SUITE 411
ORIGINAL LAYOUT
INVENTORY SUITE

*** SUITE 411 * (INVENTORY SUITE)**

SUITES 411 - NOYAC BAY

Royal Pine Homes 25 Baker Hill Blvd - Stouffville, ON Apr 04, 2018

NEW PLAN

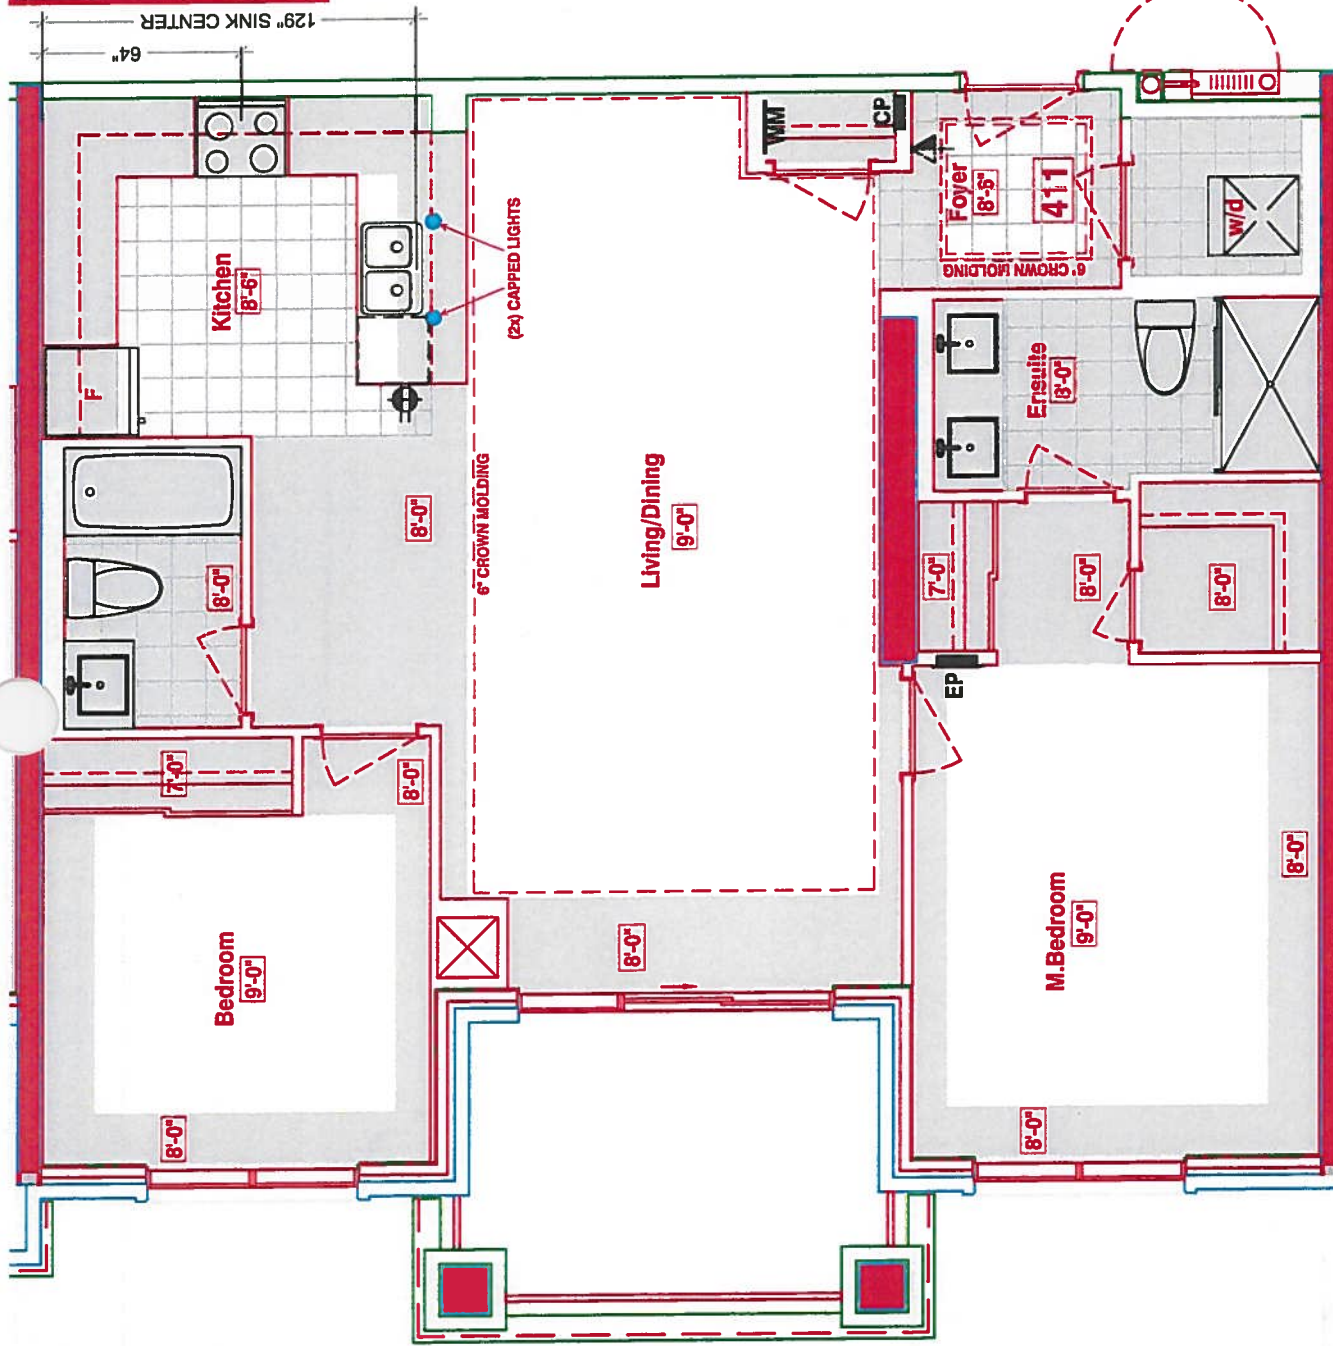
-REMOVED DEN

-REVISED KITCHEN

***REVISED LAUNDRY DOOR SWING &
ENSUITE WALL AS PER THIS BROCHURE**

KITCHEN FLOOR PLAN

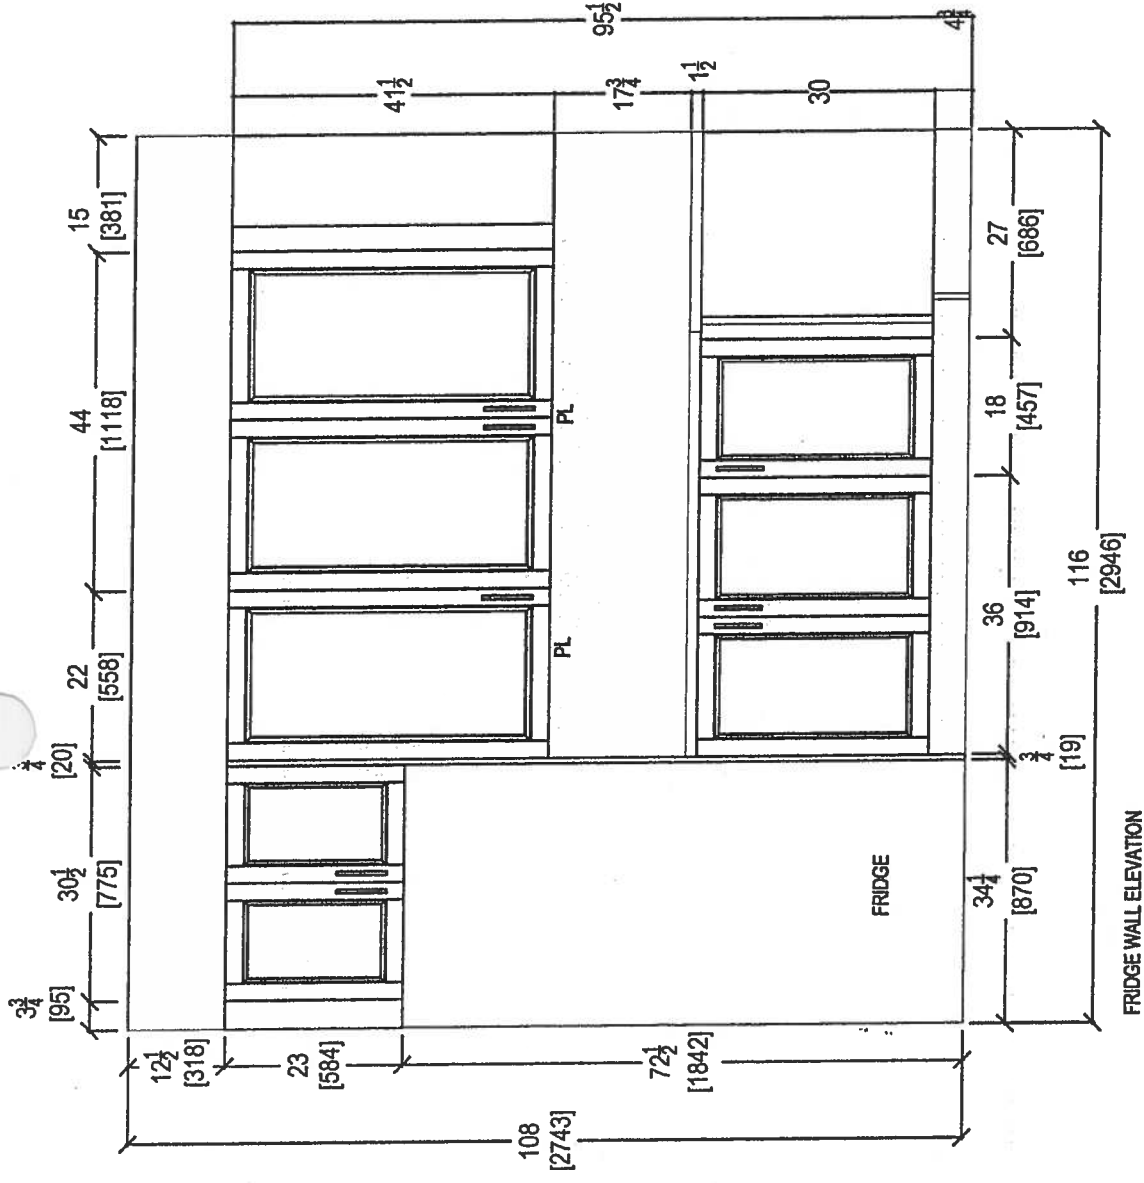
- STD KITCHEN LAYOUT
- STD APPLIANCE PKG.
- (x1) - PLUG PENINSULA
- (x2) - CAPPED PENDANT LIGHTS
- (x5) - PUCK LIGHTS
